**ARCHITECTURAL REVIEW BOARD  
MUNICIPAL PLANNING COMMISSION  
-AGENDA-  
Thursday, November 10, 2016 at 7:00 P.M.**

## MEMORANDUM

SUBJECT: Staff Memo for the Meeting of November 10, 2016

**SITE DIMENSION PLAN**

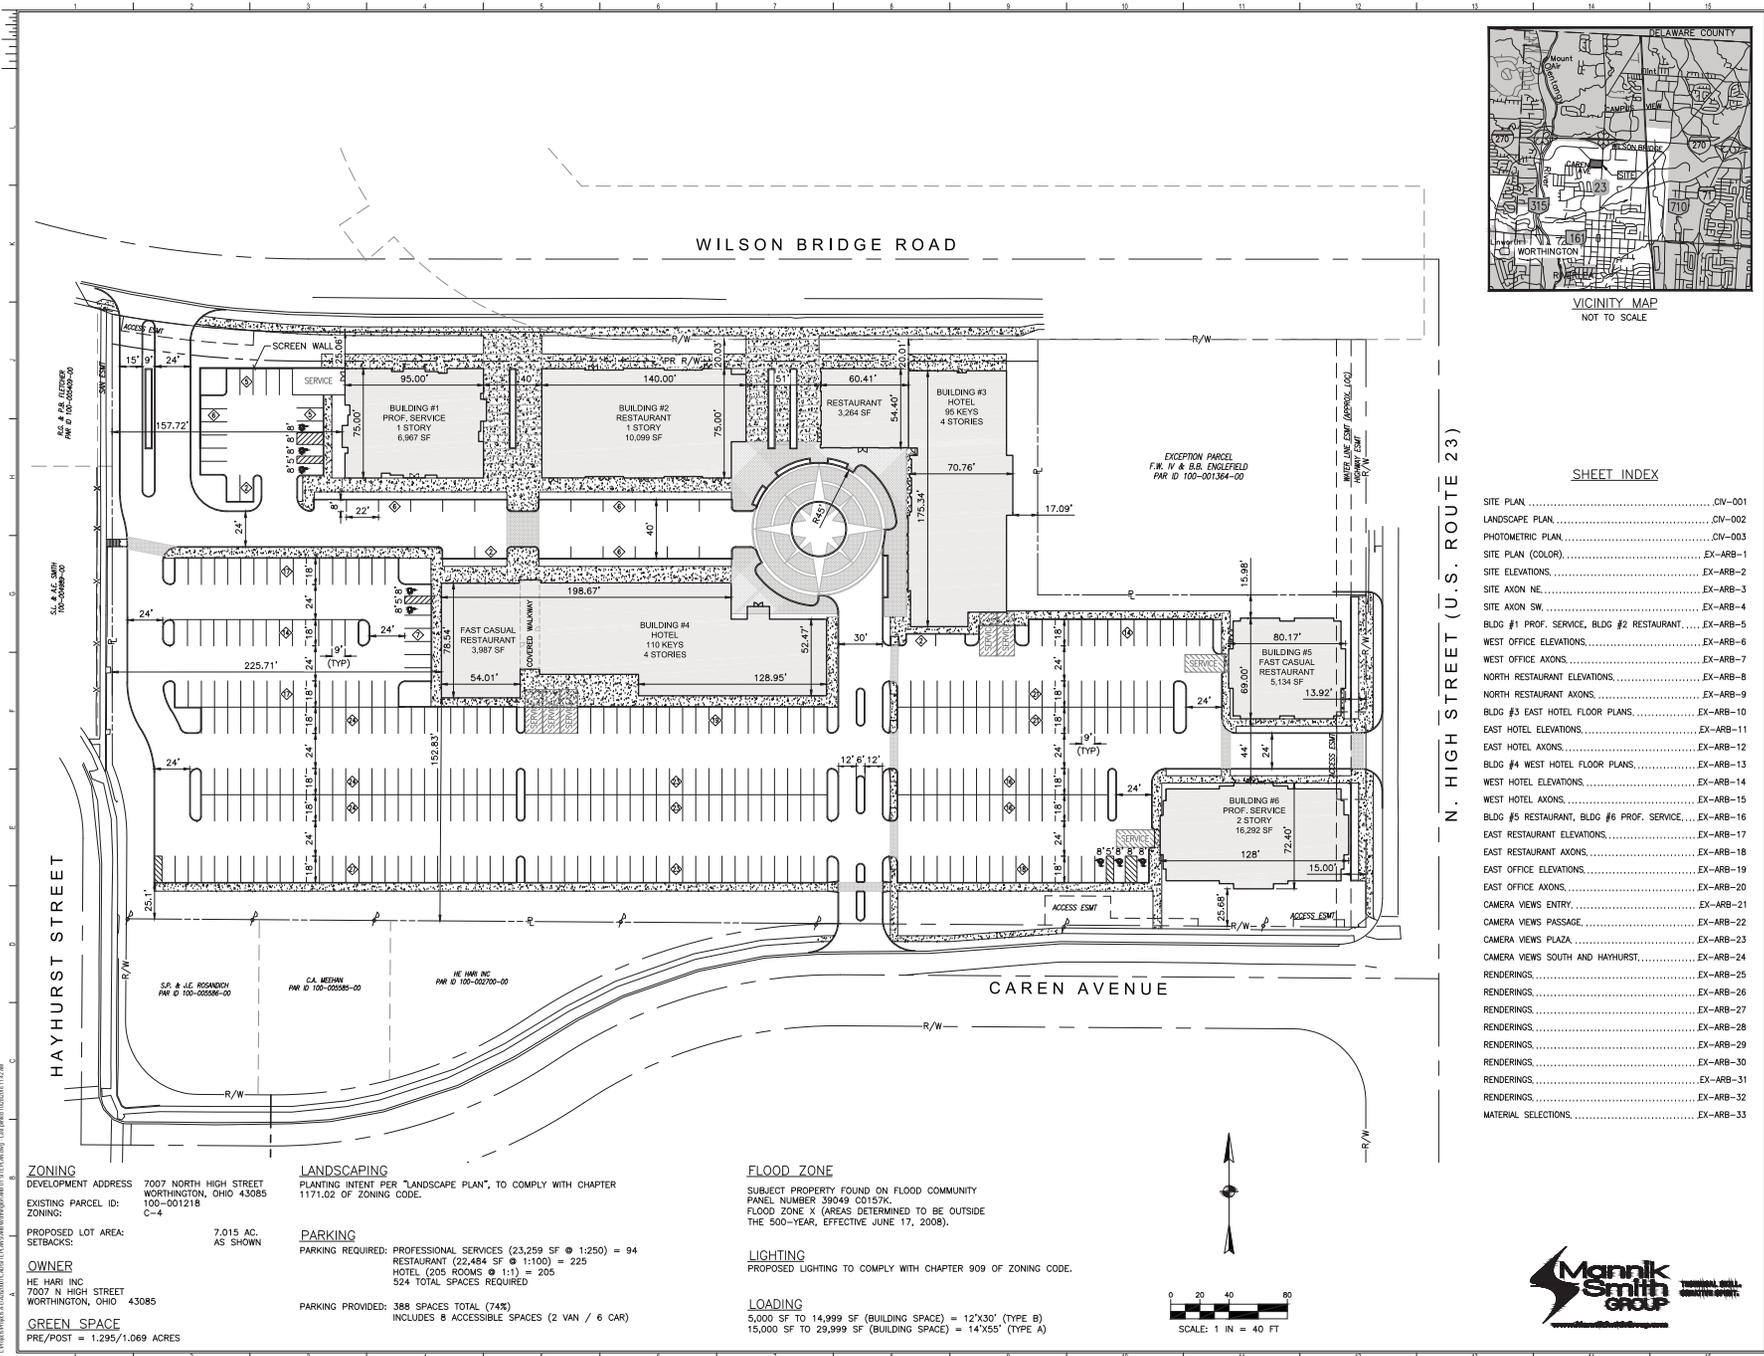
- The proposed plan shows an entrance to the site from each of the adjacent rights-of-way. All three entrances would be situated similarly to existing site entrances. On W. Wilson Bridge Rd., the entrance is proposed at the west end; on Caren Ave. the proposed entrance is toward the middle of the site but on the eastern half; and on N. High St. the entrance would be near the middle of the site. Elimination of an existing entrance toward the east end of the site on W. Wilson Bridge Rd. is proposed.

- W. Wilson Bridge Rd. - Three building are proposed along W. Wilson Bridge Rd. about 36' from the roadway and 20' from the existing right-of-way line. The City has requested an additional 15' of right-of-way be dedicated, so the building would be 5' from the new line. In addition to the existing grass strip and sidewalk in the right-of-way, an area to plant street trees and a sidewalk adjacent to the buildings are proposed. Two pedestrian access points would be provided between the buildings which would also allow for restaurant seating areas.

- Building #1 – This building would be about 158’ from the west property line, and 95’ wide. The building is designated for professional services.
- Building #2 - A 140’ wide restaurant is proposed 40’ west of Building #1 with a pedestrian access, planting and seating area between the buildings.

- Building #3 - At the east end would be a 131’ wide building housing a 95 key hotel, and a restaurant on the first floor. Between Buildings #2 and #3 would be a 51’ wide pedestrian access, planting and seating area. Building #3 would be 17’ from the east property, at the rear of the BP site.

- A traffic circle denoted as the “Village Square” is proposed between Buildings #2, 3 & 4, with a fountain in the middle. The areas adjacent to the traffic lanes would provide pedestrian access, planting and seating opportunities. The road leading to the “Village Square” from the W. Wilson Bridge Rd. entrance would be tree-lined, and have sidewalks and parallel parking. From the south entrance off of Caren Ave., there would also be tree islands and a sidewalk to accommodate pedestrians.

- N. High St. – Two buildings are proposed along the N. High St. frontage with a drive entrance between. The buildings are proposed 15’ from the existing right-of-way. Additional right-of-way dedication was discussed along N. High St. but is not shown on the plan. There would be sidewalks extending from both N. High St. and Caren Ave. to these buildings, with a pedestrian connection between the buildings.

- Stairs to the existing sidewalk west of the site are planned to allow pedestrian access for the residents.
- The remainder of the site would be surface parking with tree islands added. The applicant calculates 524 parking spaces would be required on the site based on the proposed uses, and 388 spaces are being provided. Should there be any times the site could not accommodate all of the guests, parking agreements with property owners to the south may be possible. Any parking agreements obtained would be subject to approval by the Board of Zoning Appeals with the variance request.

- A combination of evergreen and deciduous trees and shrubs are proposed to be densely planted along the west and south property lines adjacent to the existing residential properties.

- The Arbor Advisory Committee reviewed the plans and made the following comments:
  - Pyrus Calleryana (Cleveland Select) Pear trees can hybridize and are now being considered an invasive species by some, and should not be used.

- Street trees species recommendations: Exclamation London Plane; Espresso Kentucky Coffeetree; Nyssa Sylvatica “Red Rage” or “Wildfire” – Not Tupelo Tower

- Low shrubs (Taxus?) should be added along Caren Ave.
  - Only native species should be used in Caren lot (not sure if that is already the case).
  - Diversify screen planting around BP station – add arborvitae, etc.

- West/southwest screening recommendations – Viburnum Prunifolium, Canadian hemlock, Cornelian Cherry Dogwood, Arborvitae, Serbian Spruce, Winterberry and ilex x meserveae Holly. The Committee thought the Blue Spruce, which needs full sun, may not be ideal for that planting in the quantities shown.

- Need to see specs for planting (not sure what ODOT specs are)
  - Need appropriate bed depth and type of fill in parking islands
  - Why are there not any foundation plantings?

- Consideration should be given to burying overhead utility lines at the south property line.
  - A storm water plan will be required.
  - A preliminary traffic study has been submitted, but additional information will be needed to determine the viability of installation of a traffic signal at the W. Wilson Bridge Rd. entrance.

1. The proposed site plan generally reflects the discussions at the ARB meetings, and is appropriate for the site. Consideration should be given to eliminating the sidewalk near Wilson Bridge Rd., and instead running the sidewalk up to and along the buildings. The sidewalk would then lead pedestrians to the site and be better protected from traffic, and a wider, more prominent planting area would be created adjacent to the street.
2. Right-of-way vacation along both streets is still requested, but has only been shown along W. Wilson Bridge Rd.

6. Staff is recommending *tabling* of this application after discussion, to allow the applicant to make modifications and add detail based on the guidelines and any recommendations made at the meeting.
